SITE PLAN REVIEW AND APPEARANCE BOARD

Delray Ridge

Meeting	File No.	Application Type
June 22, 2022	2022-109	Class II Site Plan Modification
Request		
Consideration of a Class II Site Plan Modification, Landscape Plan, and Waiver for Delray Ridge associated with the development of 14 single-family homes and site improvements.		
Applicant	Property Owner	Authorized Agent
Ron Ellish, Delray Ridge, LLC	Delray Ridge, LLC	G. Allan Hendricks, Caufield & Wheeler Inc.

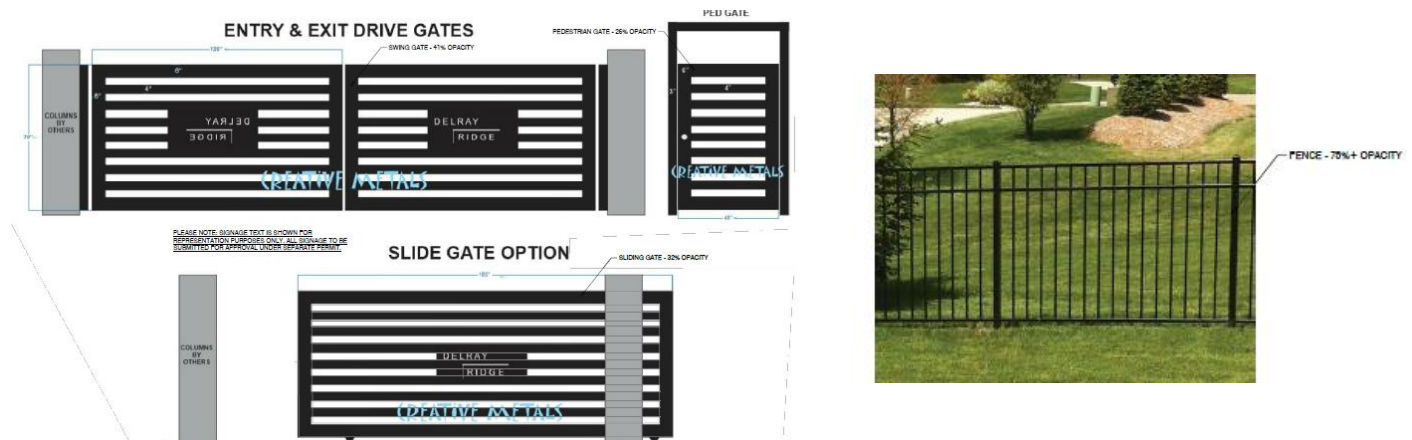
A 6-foot-high precast site wall, painted with white color, is proposed along the perimeters of the development. For the areas subject to site visibility clearance, the fence with 75 % opacity is incorporated to the site wall design. Decorative horizontal gates are proposed for the main entrance along N. Swinton Ave and the egress along NE 22 Street.

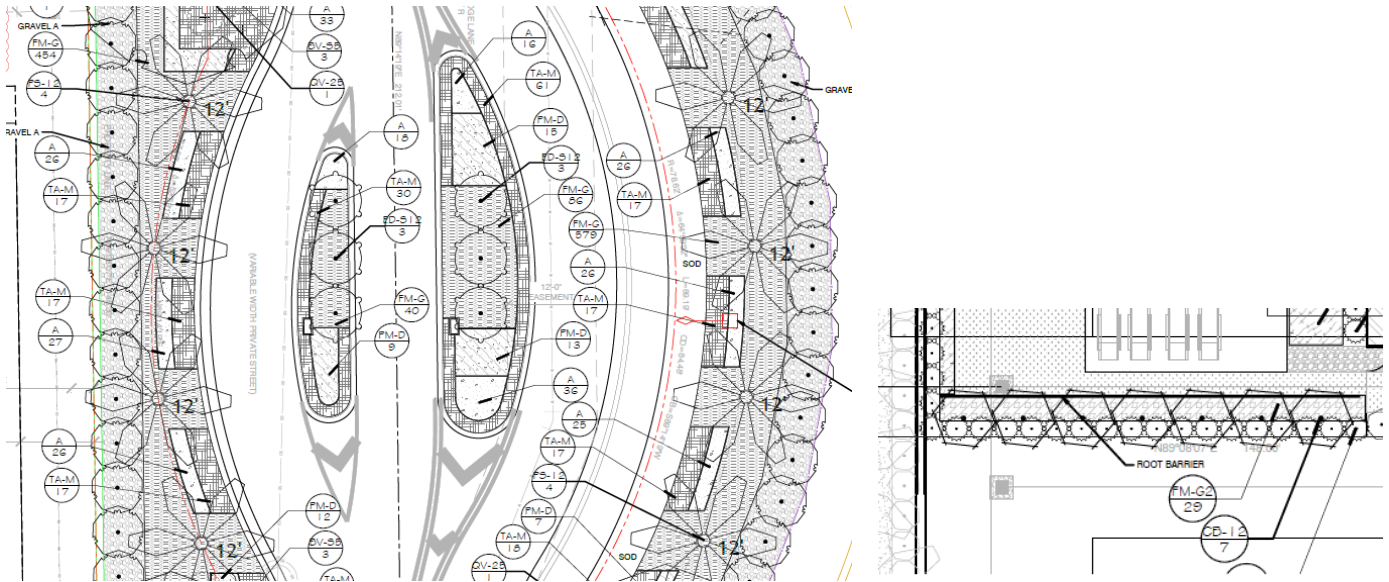
2. The applicant proposes Brazilian Beautyleaf trees (CB: Calophyllum Brasiliense) to create the visual barriers along the main entrance and interior perimeters for individual lots. The space arranged for those trees is less than 10 ft interval, which may stress an overall growth of such trees as defined in LDR Sec. 4.6.16 (E)(5), quoted below. The project landscape architect is confident that the space given for these trees would not be concerned for the growth but provide a visual barrier and enhance the appearance of the development.
